# Toronto Water Review

**Presentation to:** Councillor Crawford, TRCA - Nancy Gaffney, City Planning -  
Christian Ventresca, Engineering - Saleem Khan, Toronto Water - Amy Winterhalt  
**July 7, 2022**

Cliffcrest Scarborough Village SW Residents Association

RE: Geotechnical Concerns, Rezoning and SPA Application No: 20 209863 ESC 20  
OZ; 20 209873 ESC 20 RH, 3291 KINGSTON RD/2-4 WINDY RIDGE DR

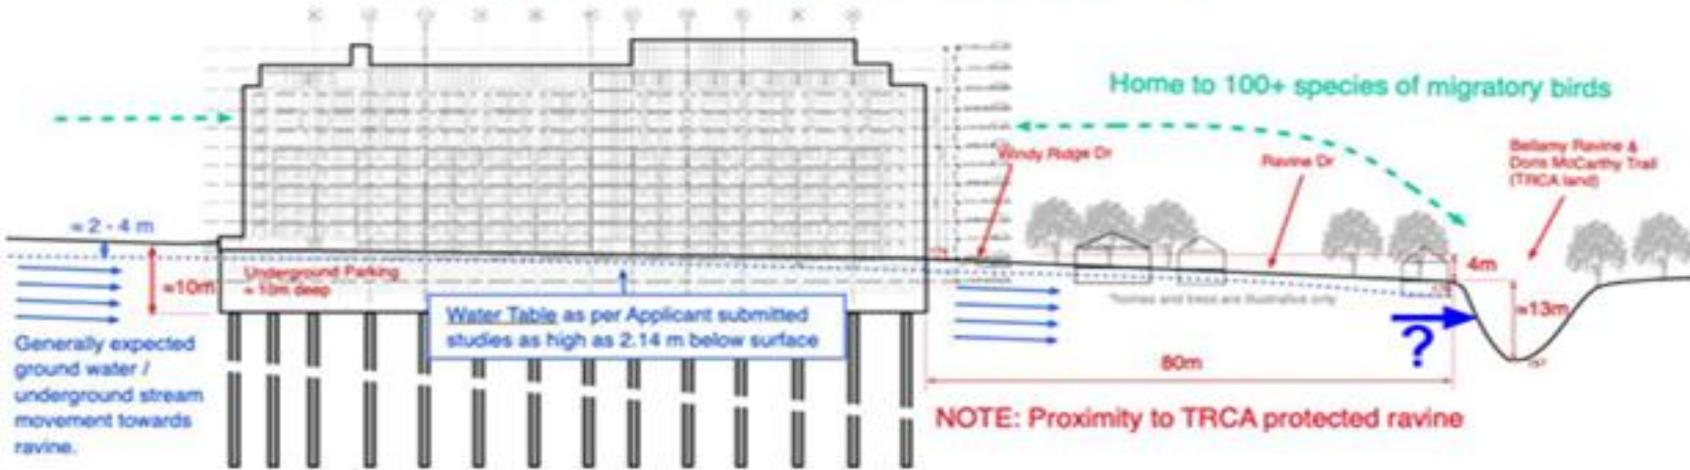
Today we want City Teams to have foresight The City is accountable and City Planning and TRCA are responsible for protecting the residents and environment from sinkholes and flooding caused by damming from the developments design and construction, and mitigating erosion of Scarborough's ravines and the Bluffs.

Due diligence is needed to ensure the proposed developments are scrutinized differently when located on or by environmentally sensitive lands.
